In comparison with OK_IC, ON / OFF timing of the gate is abnormal in the case of NG_IC.

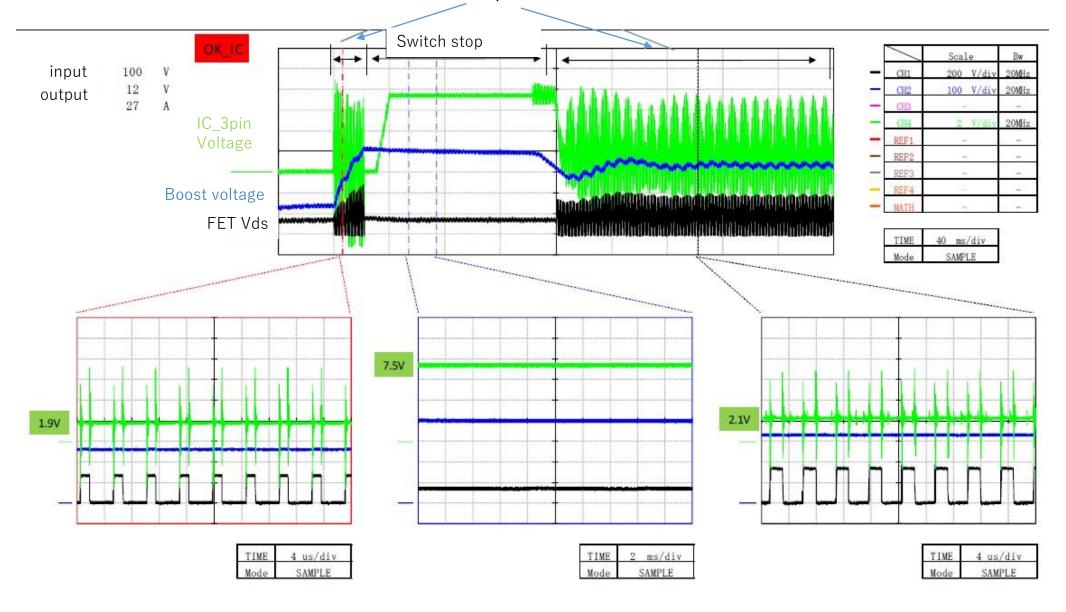
Why is this behavior?

Please tell me the possible causes.

Switch operation

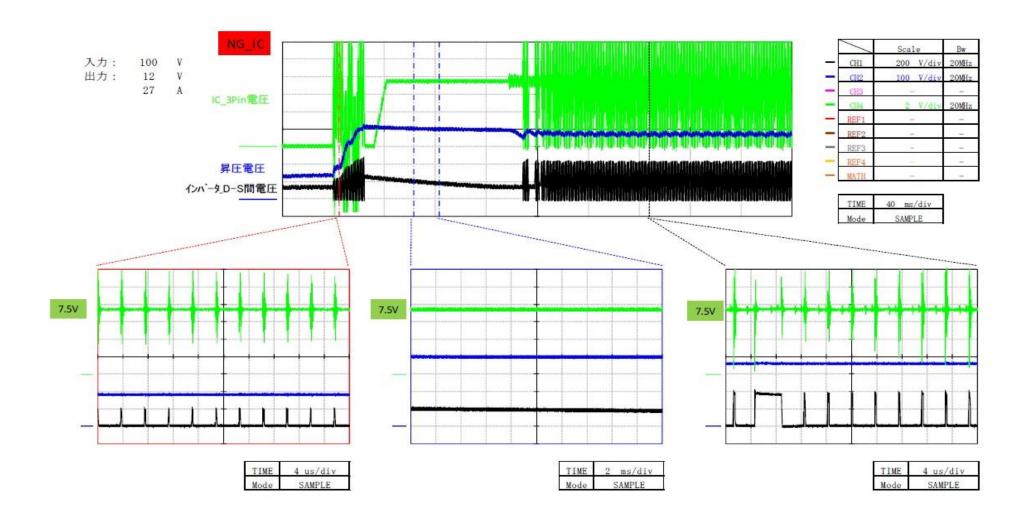
In the case of OK_IC: When looking at the 3 pin voltage, the switch amplitude swings between 7.5 V and -2.5 V around 2 V at the time of switch operation. However, in the case of NG_IC, it swings between 12 V and -0.5 V around 7.5 V.

Why is this? (what is the reason?)
